Owner Change Order

Project No.: 021192
Project Name: 9 Riverside Police Station
Contract Date: 11/18/2024
Contract Number: 021192
Change Order Number: 00002
Owner's CO Number: 2

Project: 9 Riverside Police Station

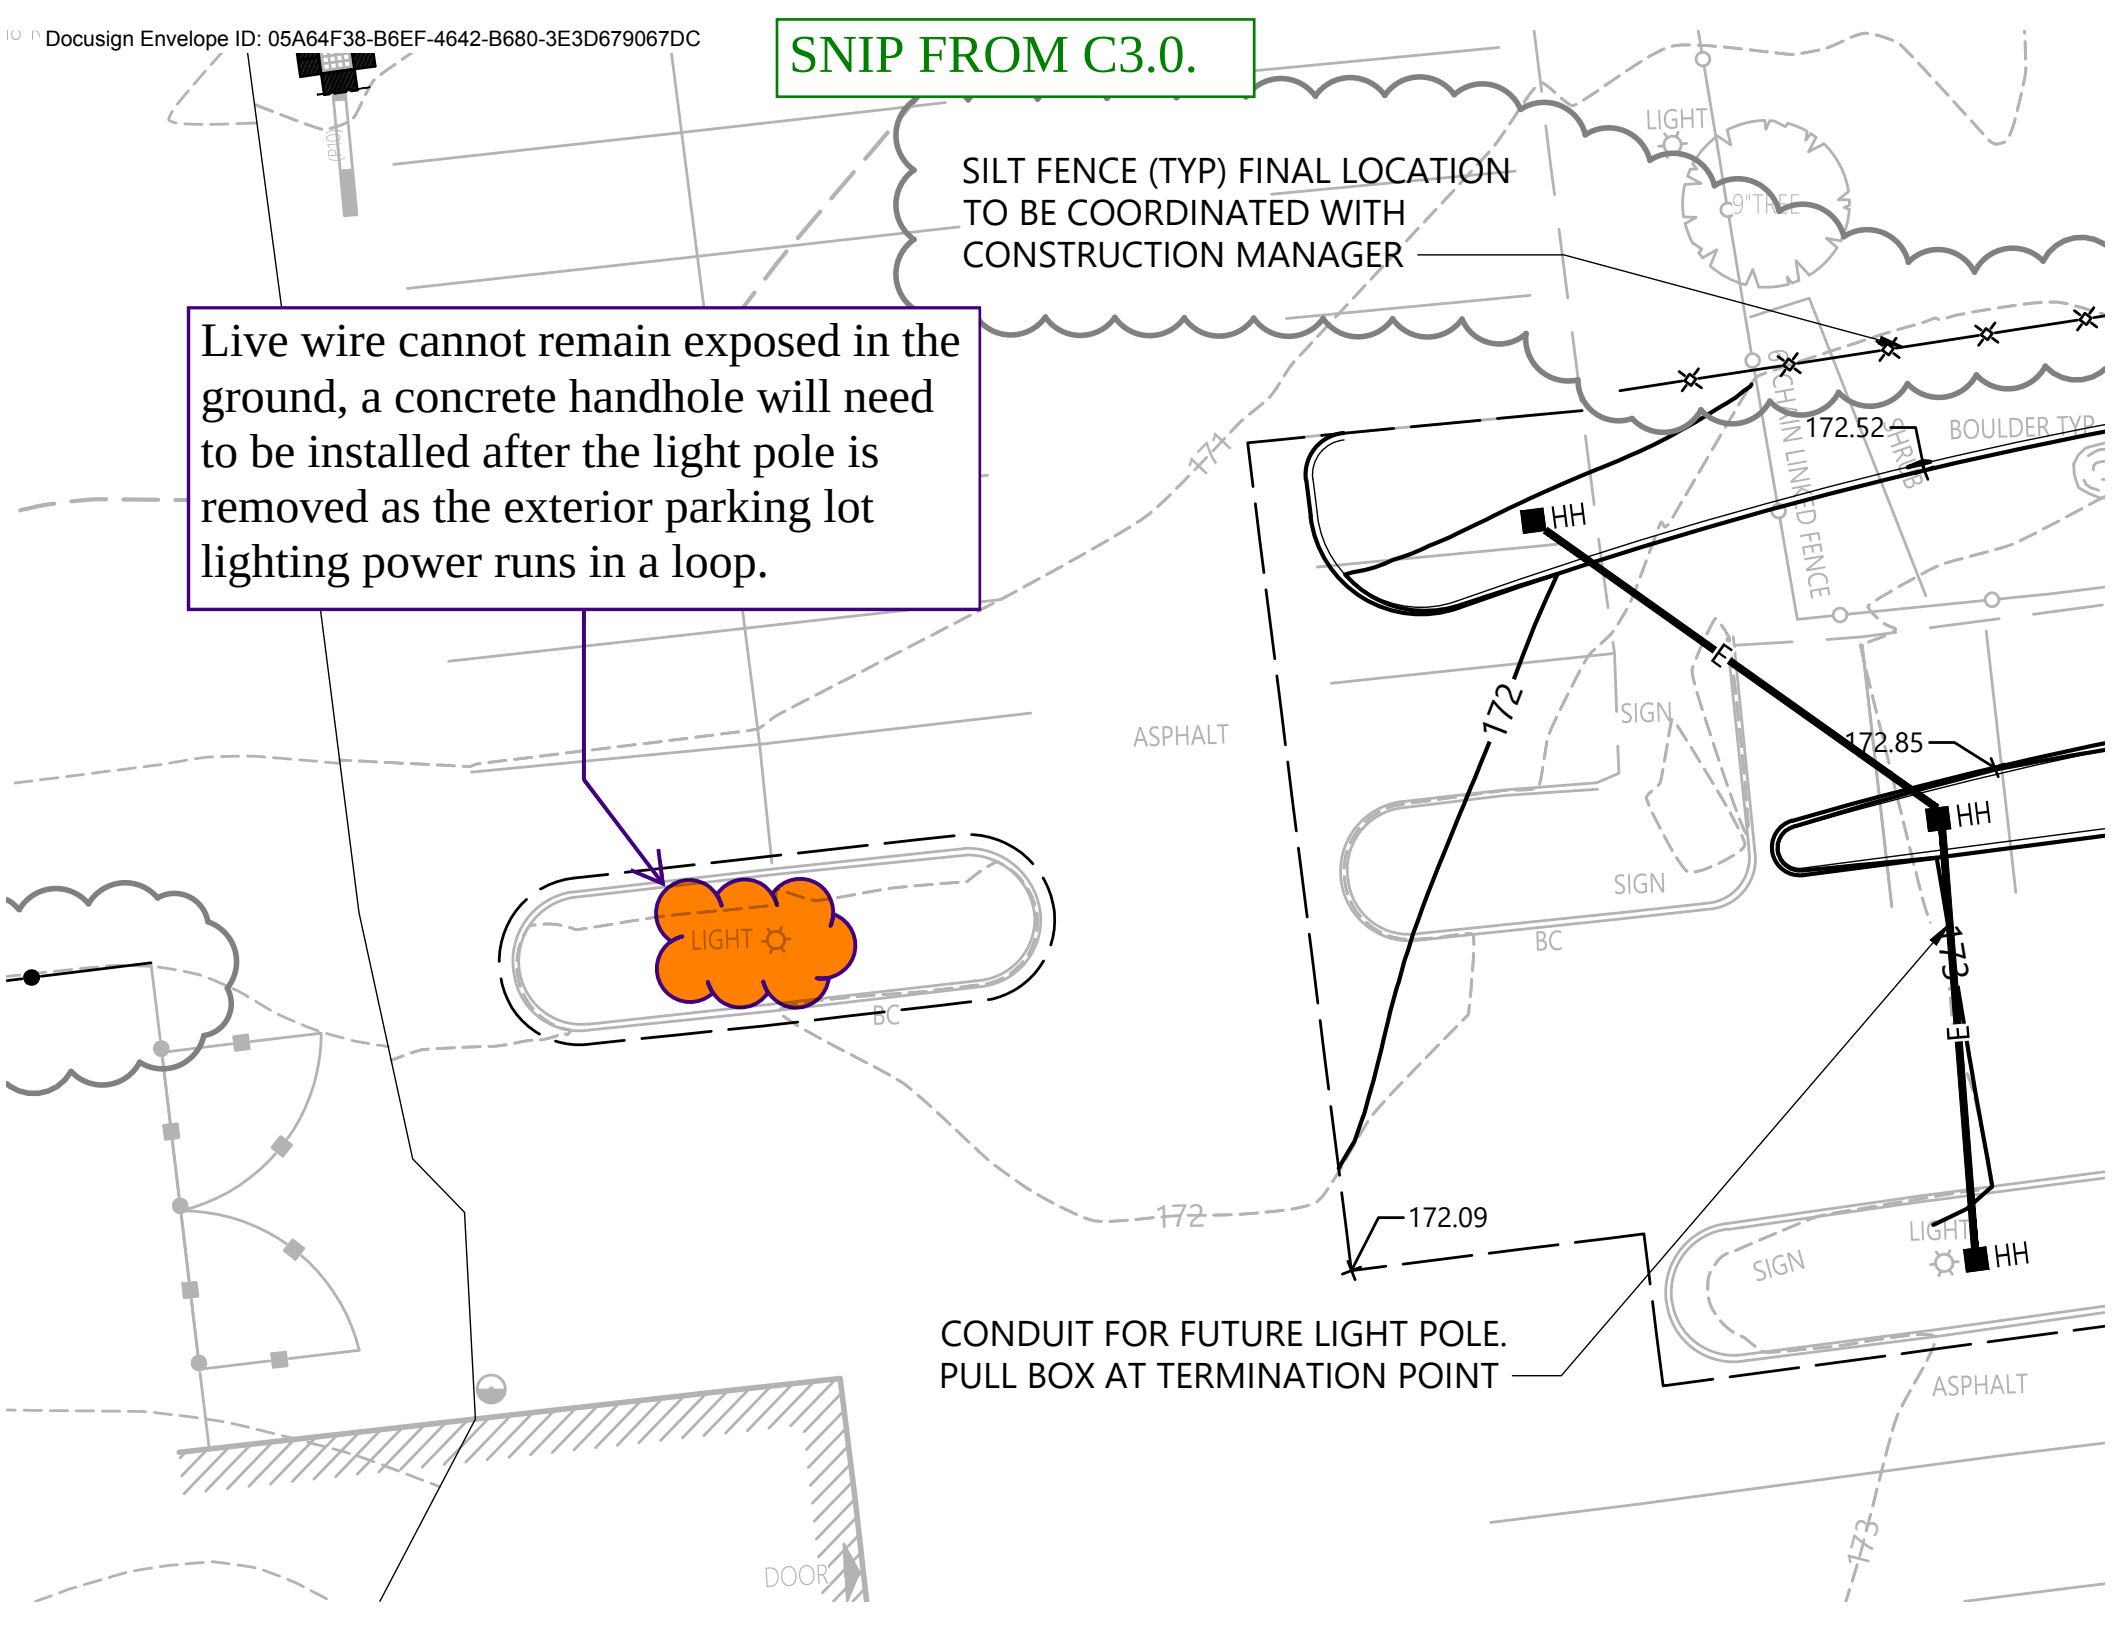
Question Date Required: 05/23/2025									
At the plan west island and light pole that is called to be removed, a handhole is required as live wire cannot be left exposed in the ground. The wire must remain live because the light poles in the PD parking lot are all on 1 loop, thus disconnecting the 1 would be disconnecting them all. As a result, a concrete handhole needs to be installed at this location. Please confirm installing a concrete handhole at the location shown in the attached sketch is acceptable.									
Suggestion									
<table border="1"> <thead> <tr> <th>Cost Impact</th> <th>Cost Amount</th> <th>Schedule Impact</th> <th>Days</th> </tr> </thead> <tbody> <tr> <td>YES</td> <td></td> <td>No</td> <td></td> </tr> </tbody> </table>	Cost Impact	Cost Amount	Schedule Impact	Days	YES		No		No Suggestion Provided
Cost Impact	Cost Amount	Schedule Impact	Days						
YES		No							
Notes

- Minimum requirements shall be that all sections of the product shall be designed for HS-20 loading.
- Submit a shop drawing for a product for review.

**SI-01 - EXISTING WALL MODIFICATIONS AT DOORWAY
#RS-110**

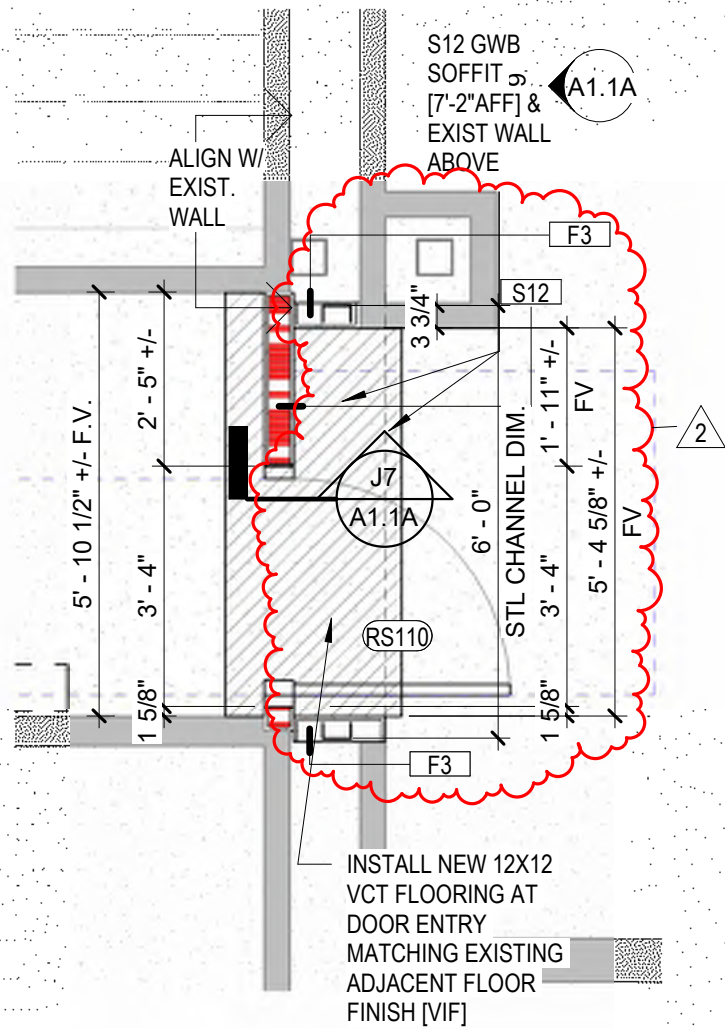
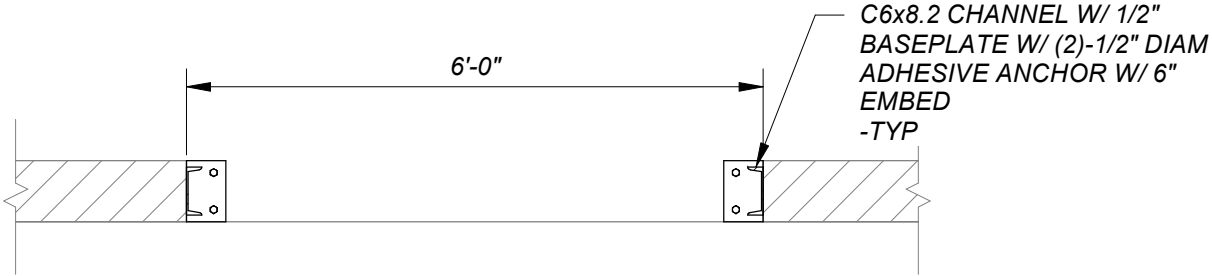
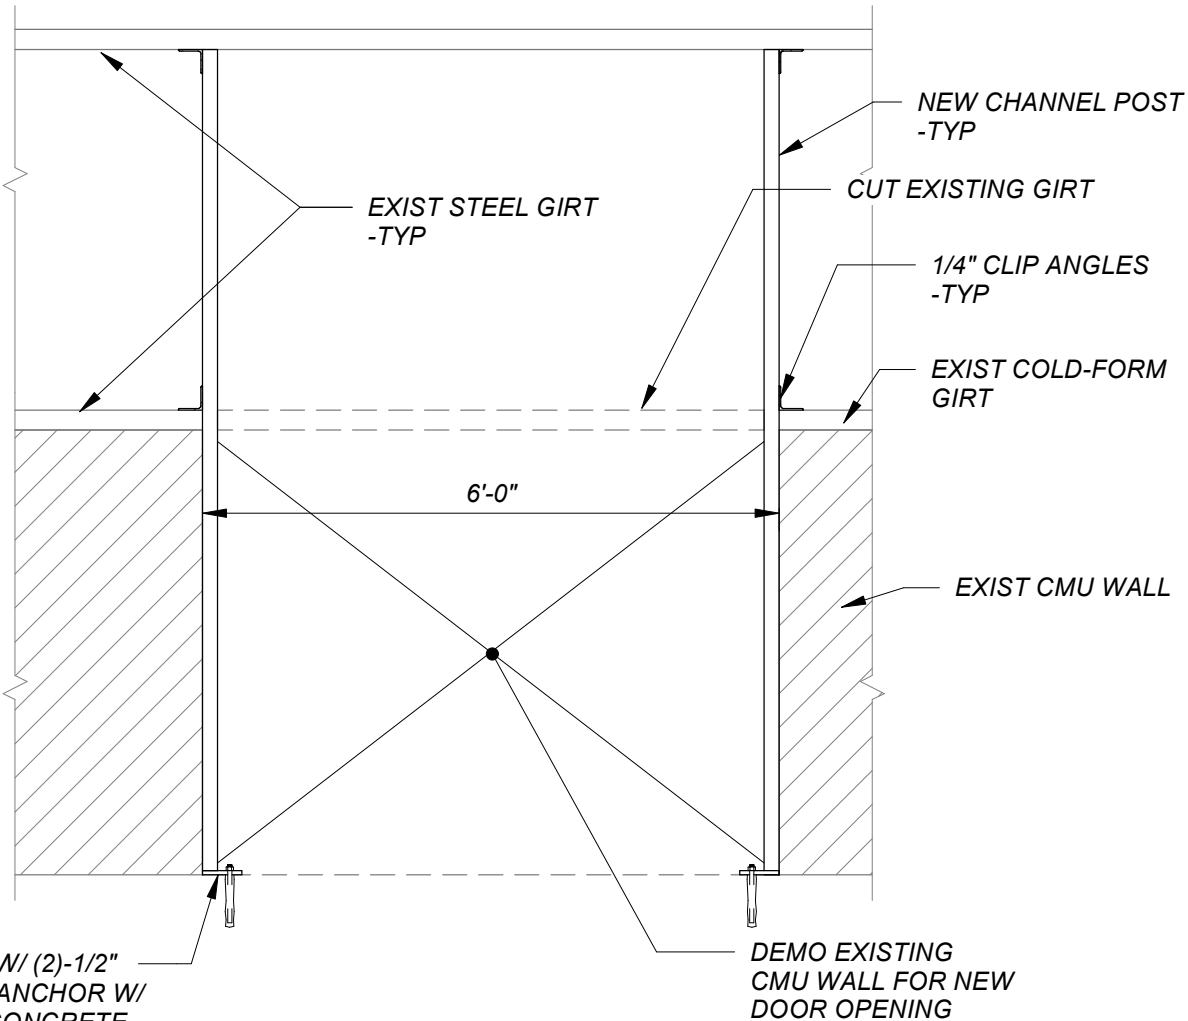
The contract documents show two 2x4 wood framed walls separating the new City Data Room from the NTS side of the building however while demolishing the existing wall for the added door opening, Whiting-Turner discovered a structural wall composing of CMU, Insulated Metal Panels (IMP's) and horizontal steel support girts. Because this wall is structural, Whiting-Turner submitted RFI #016 requesting additional instruction and the response was returned stating that a Supplemental Instruction (SI) would be provided.

SI-01 Wall Modifications at Door RS110 was issued, instructing to demolish the CMU, IMP's and first steel girt and installing supplemental support steel (C-channel) at the opening.

Costs for this change are for labor and materials to remove CMU, IMP's & the steel girt and install 2 pieces of C-channel. The C-channel is to be fastened to the concrete floor using 1/2" baseplates and fastened to the structure using 1/4" clip angles. All work shall be performed in accordance with the sketches issued in SI-01.

New structural framing and adjusting of new stud walls locations will be necessary.

F&I (2) C6x8.2 w/ angle clips, baseplates. Add for demo of girt.

1
E310
ELECTRICAL GARAGE POWER PLAN
1/4" = 1'-0"
0 2 4 6

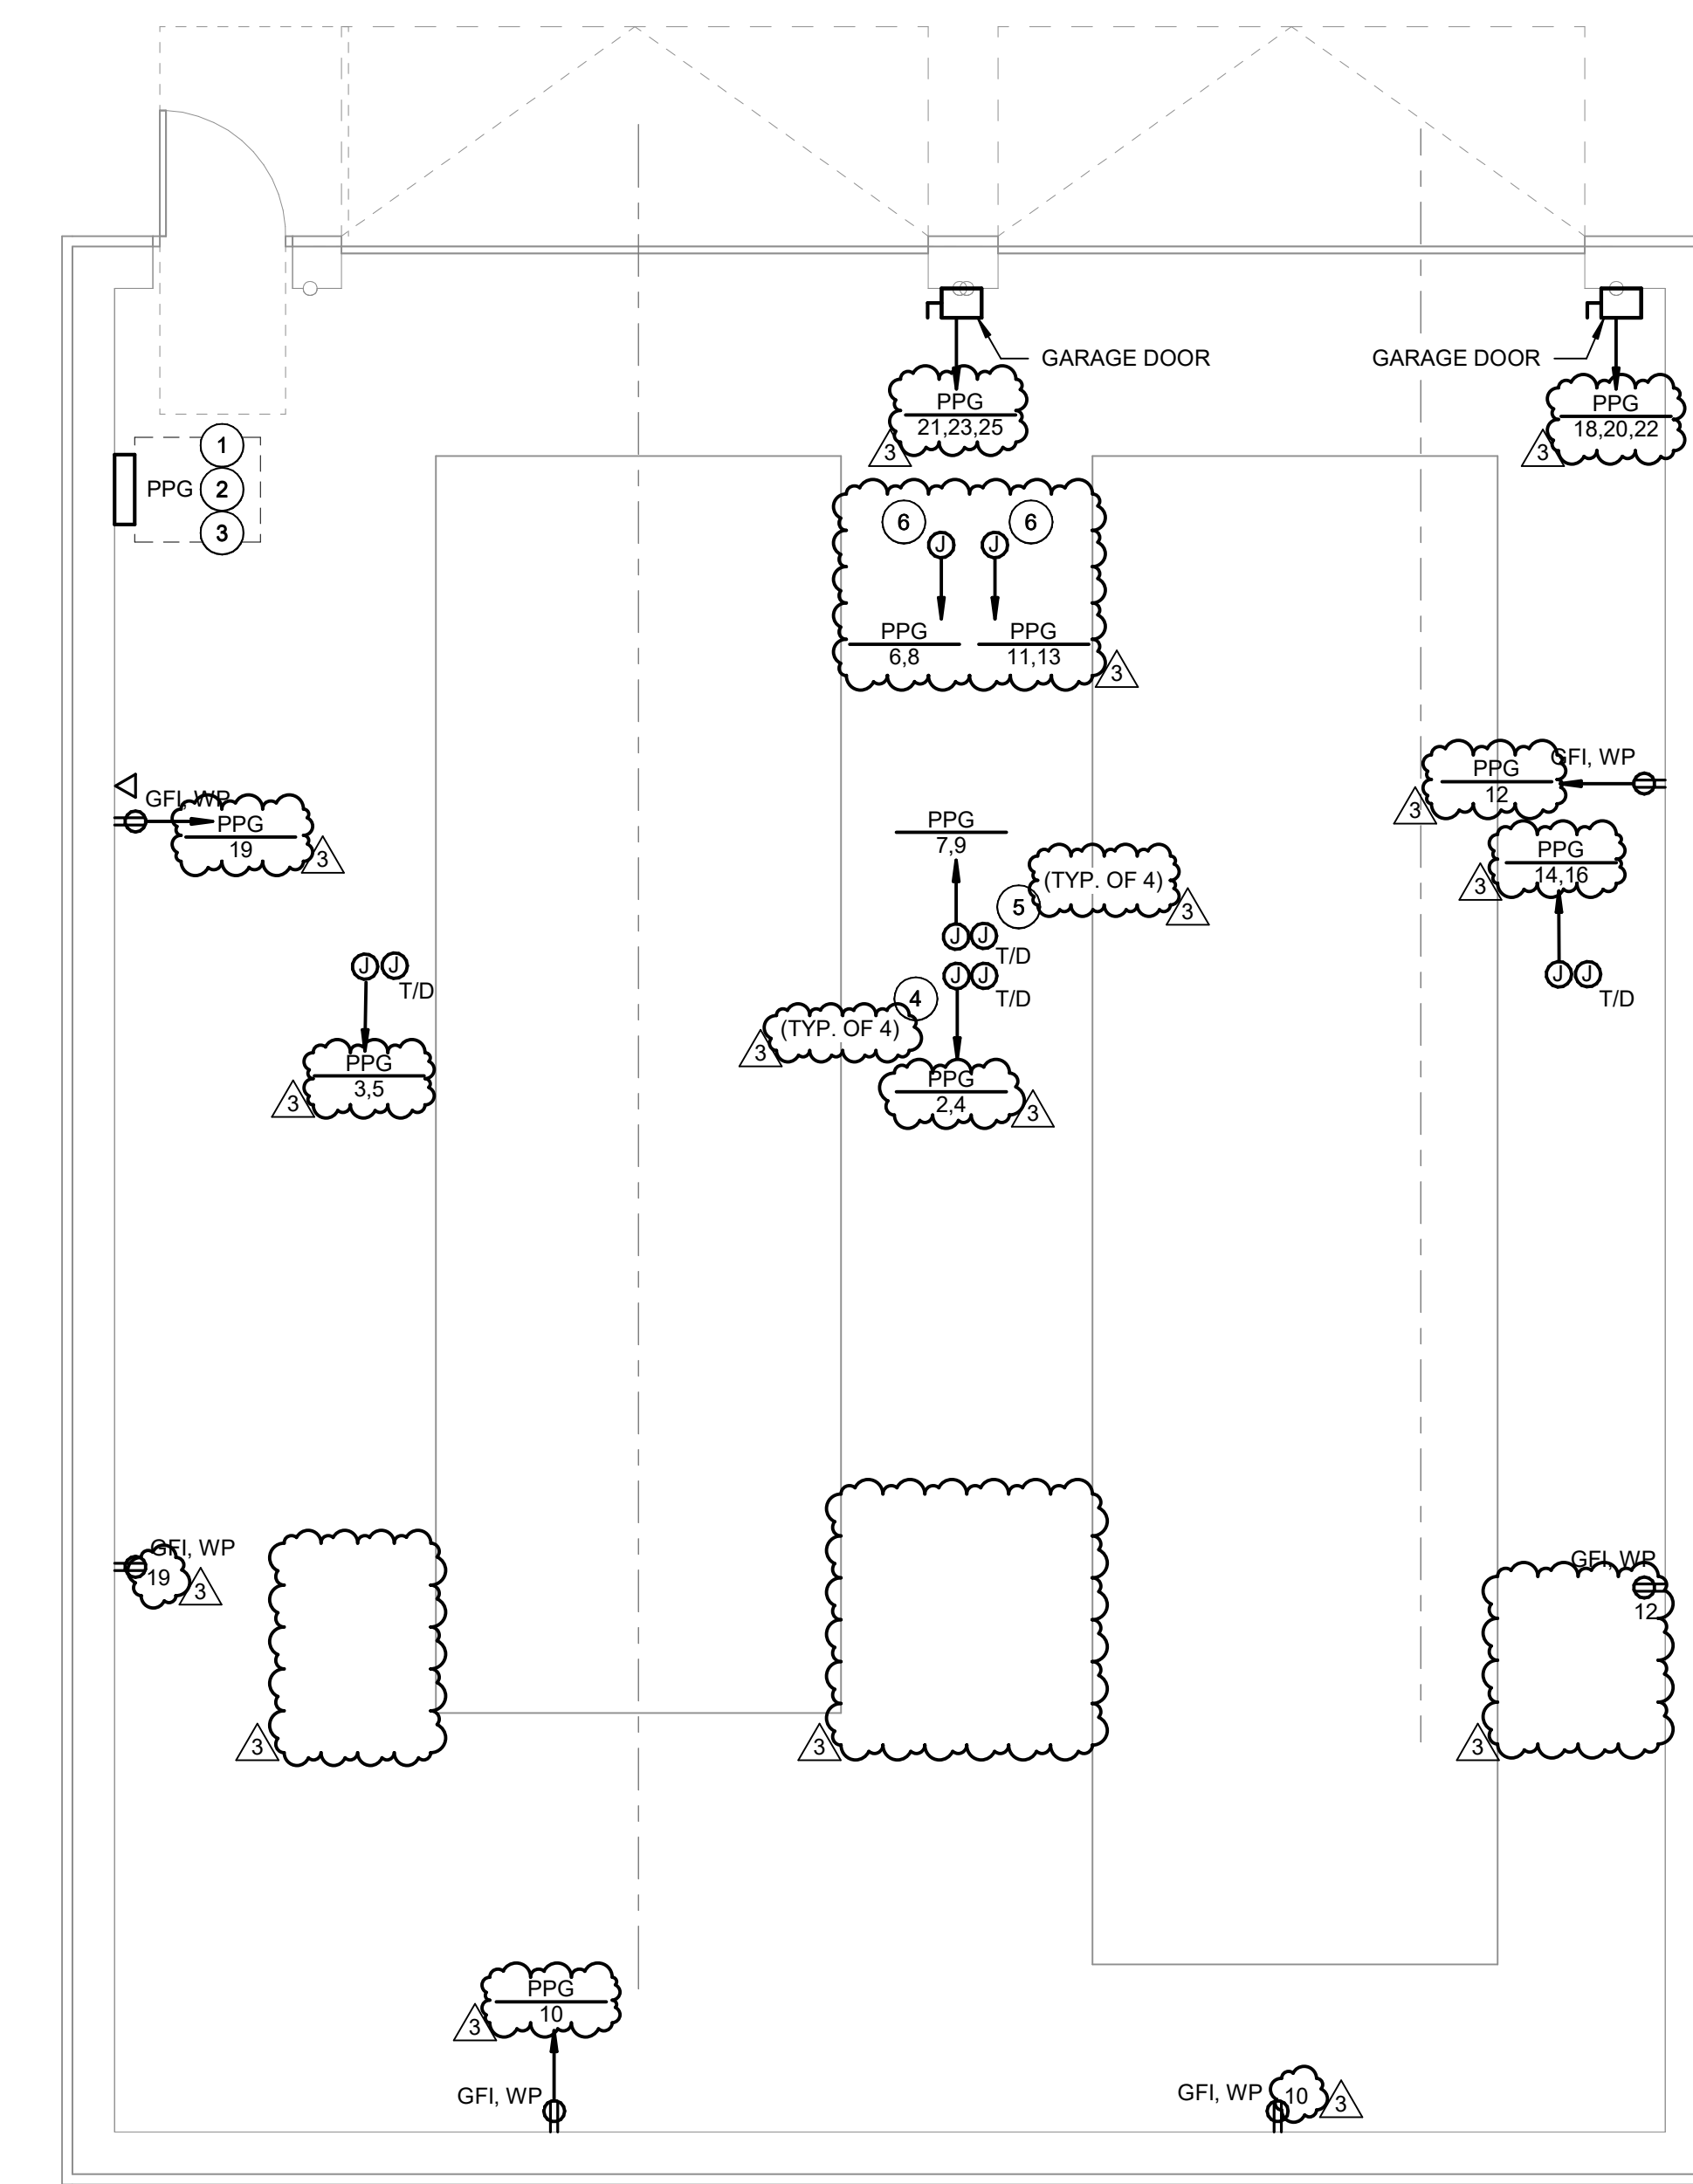
SCOPE OF WORK: Whiting-Turner submitted RFI #013 requesting additional information on the configuration of the Garage Cord Reel Caps. The response was returned providing a configuration but also noting that the cord reels are to be 50A in lieu of the specified 30A. SI-03 was issued, replacing the (8) 30A cord reels with (4) 50A and (2) 20A cord reels. As such, the power feeds to the cord reels have to be upsized to accommodate the additional amperage. In order to fit the upsized feeds into conduit, the conduit size has to increase from 1-1/4" to 1-1/2". SI-03R2 was issued, providing additional instruction regarding the upsized feeders, conduit and breakers.

Material costs associated with this change are for 1-1/2" conduit from the main distribution panel MDP-1 to the new garage panel PPG, 1-1/2" conduit accessories, (4) 50A cord reels, (2) 20A cord reels, upsized MC cables, (9) new breakers, and deducts for (8) 30A cord reels and (8) 30A breakers removed from scope.

- KEYNOTES**
- 1 RUN #1, 1#6G IN 1-1/4" FROM MDP-1 LOCATED WITHIN MAIN ELECTRICAL ROOM TO NEW GARAGE PANELBOARD PPG. PROVIDE WITH NEW 100A/3P CIRCUIT BREAKER TO SERVE PPG. UNDERGROUND PORTION OF PVC CONDUIT SHALL BE TRANSITIONED TO 1-1/2" FROM 1-1/4".
